SHEET TITLE:
Basement 2

PROJECT:
Residential Flats Building
18-22 Lords Avenue + 421-425
Pacific Hwy, Asquith, NSW 2077
JOB No.:
8433 DA:F 03

SHEET TITLE:
Mezzanine Floor Plan
DESIGNED: AHM
DRAWN: AH
COMMENTED:
SCALE: AS NOTED
PRINT: A1 SHEET
L.G.A: Hornsby Council

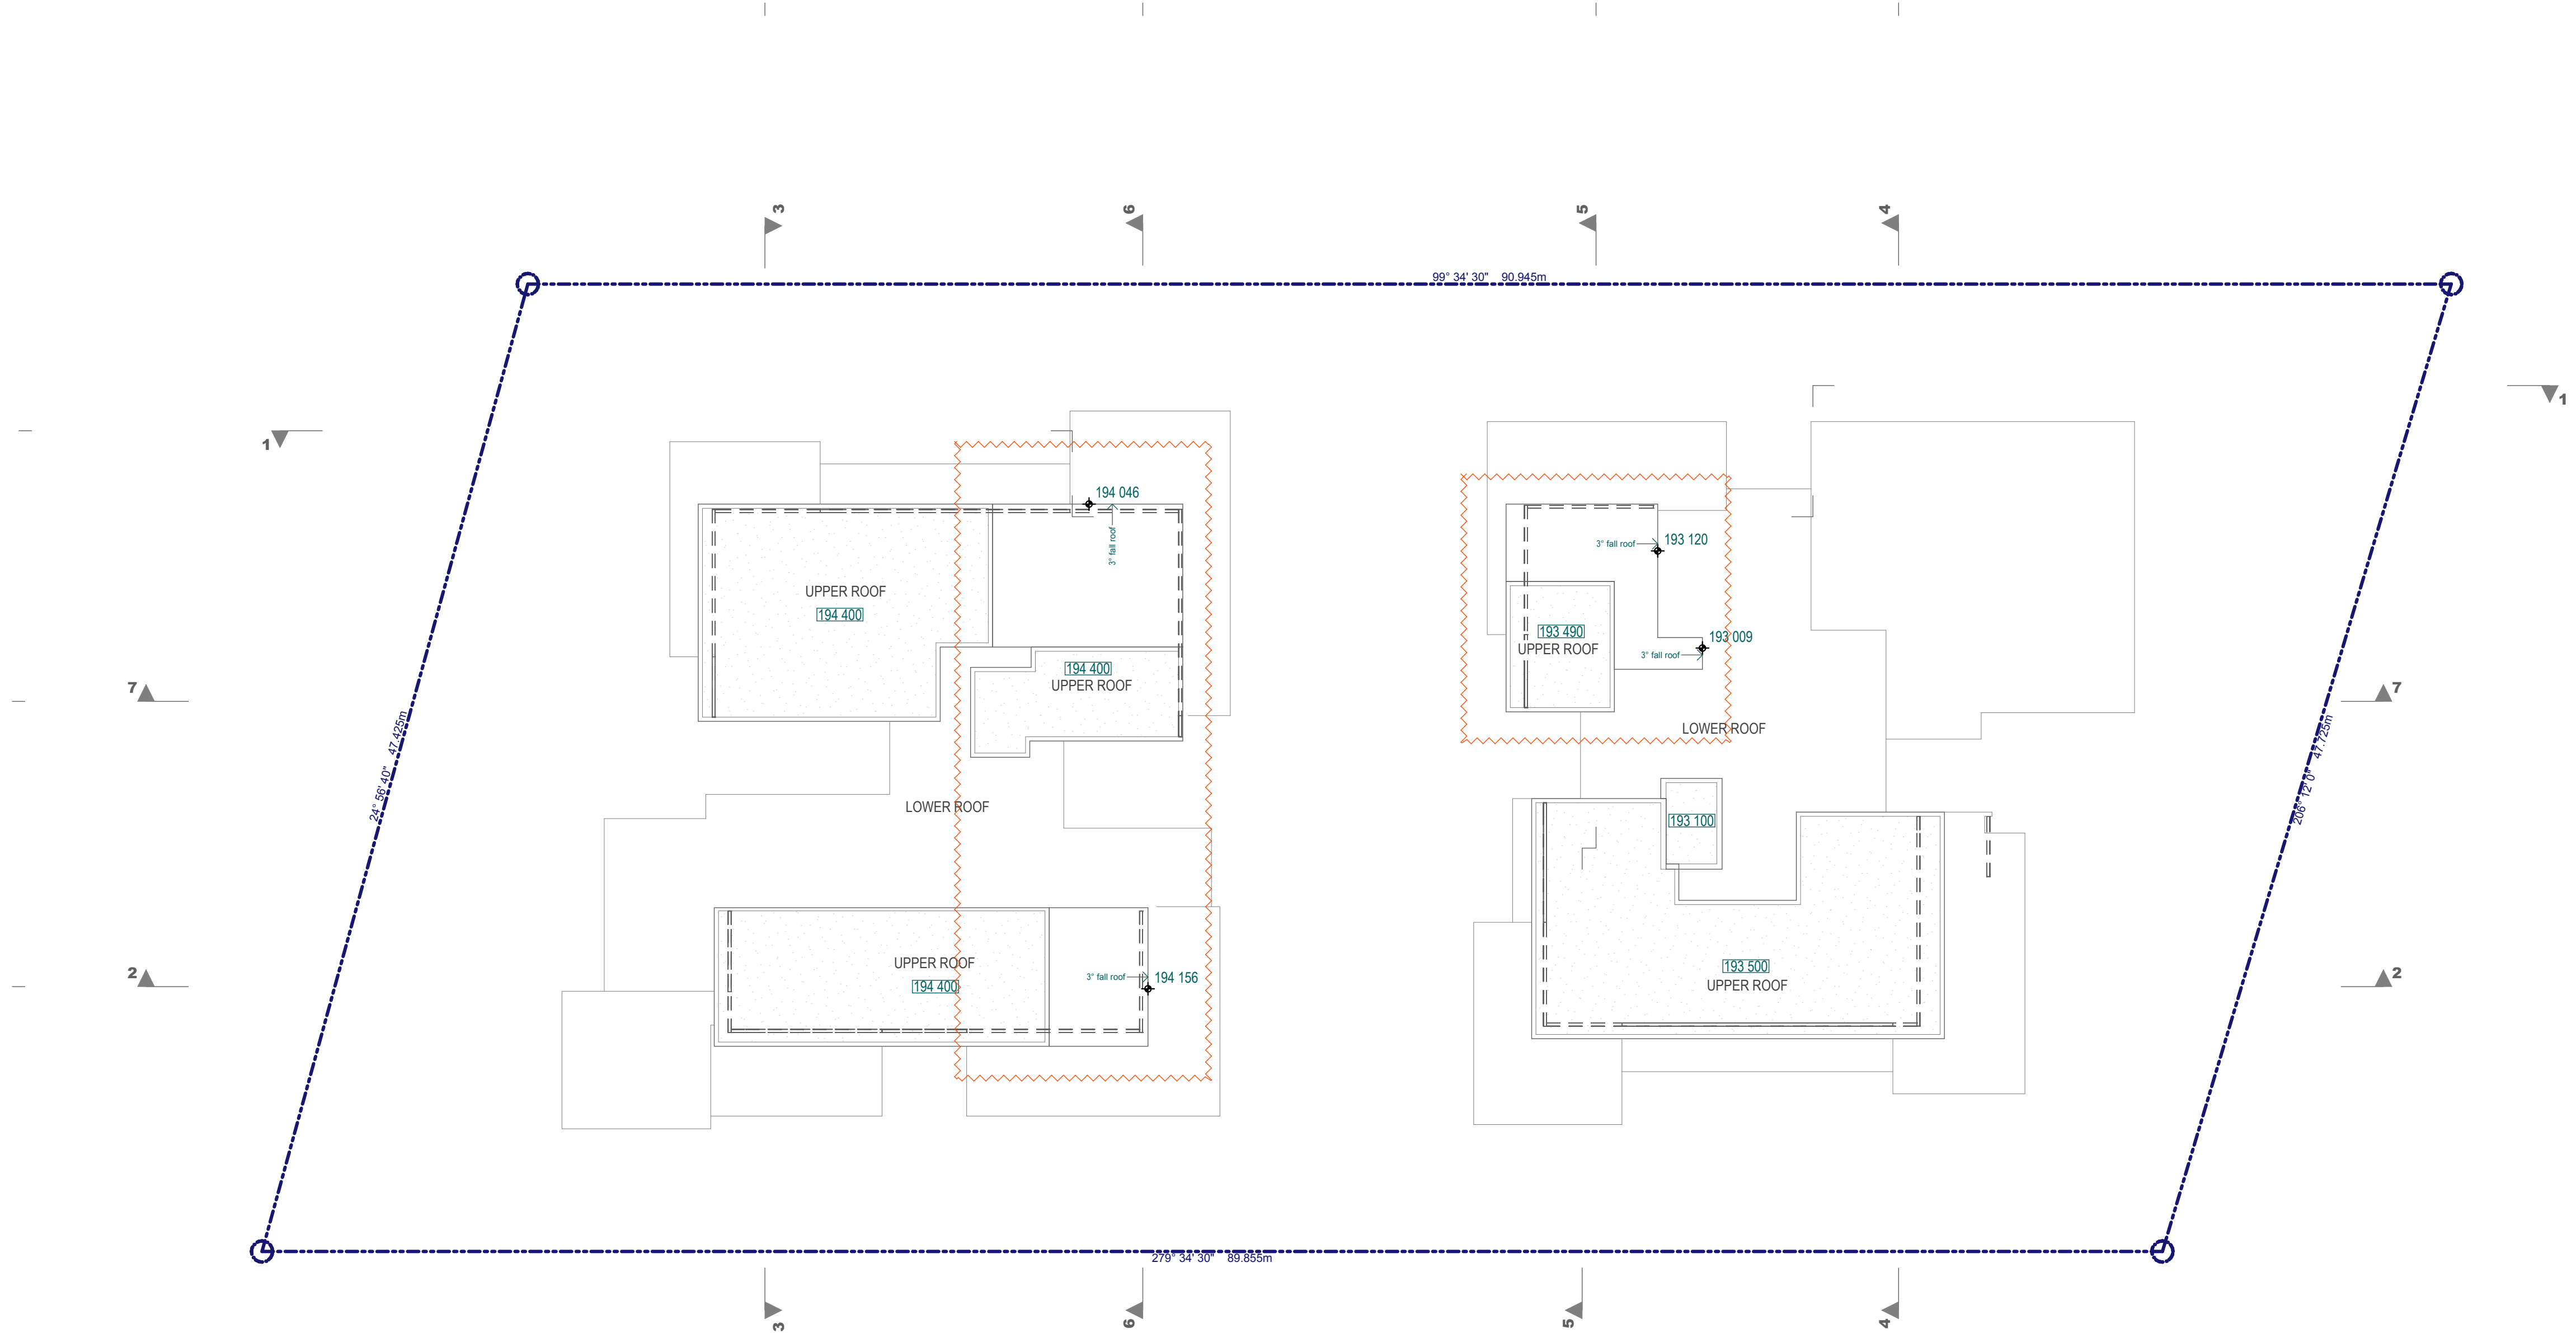
ISSUE DA-F
- SLOPED CEILING OVER VOID AREA TO UNIT B-402, B-403 B-405
PER ROOF FALL.
- ADJUSTED MEZZANINE LOCATION AND LAYOUT TO UNIT A-401.
